**Charlotte Historic District Commission**

Staff Review HDC 2014-081 Application for a Certificate of Appropriateness

**PROPERTY ADDRESS:** 1432 Pecan Avenue

**SUMMARY OF REQUEST:** Accessory Structure

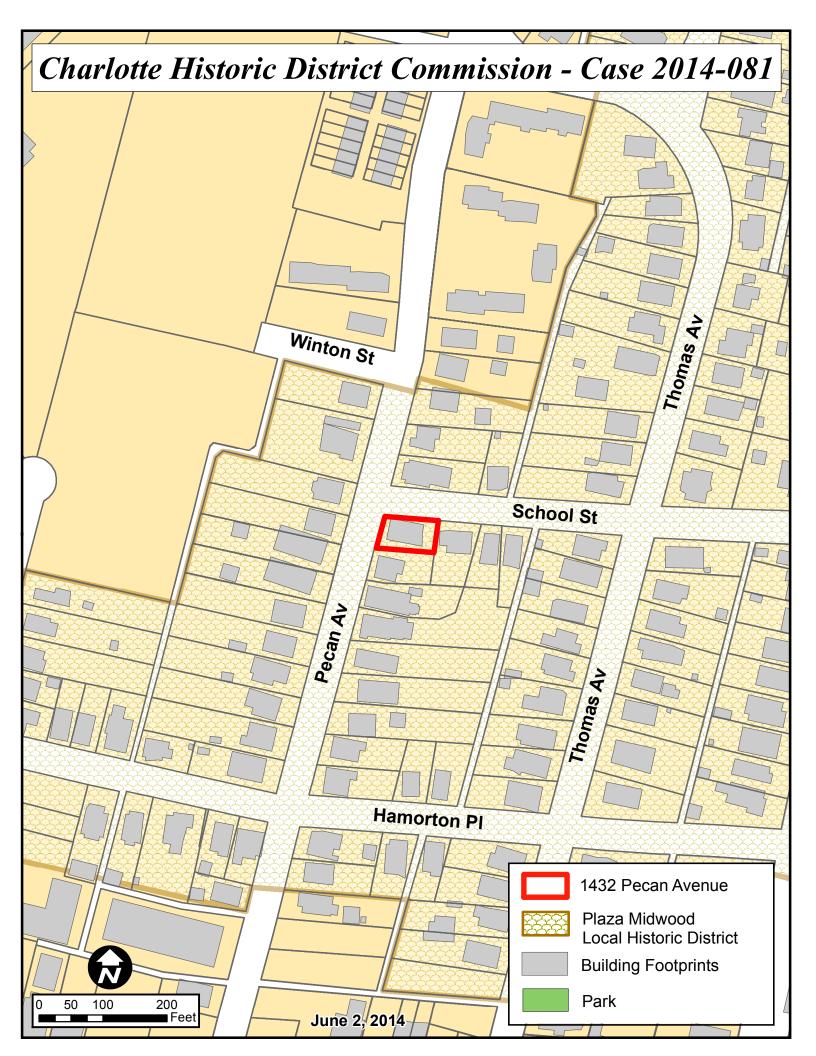
The applicant is requesting an exception to the guidelines for accessory buildings. The proposal is a detached one story accessory building in the right side yard. The building must have a minimum building separation of 4 feet. The proposed building is 10 feet in height with OSB siding, asphalt shingles to match the home and composite trim. The door would face the right side.

The Commission shall determine if an exception should be granted for the accessory building location.
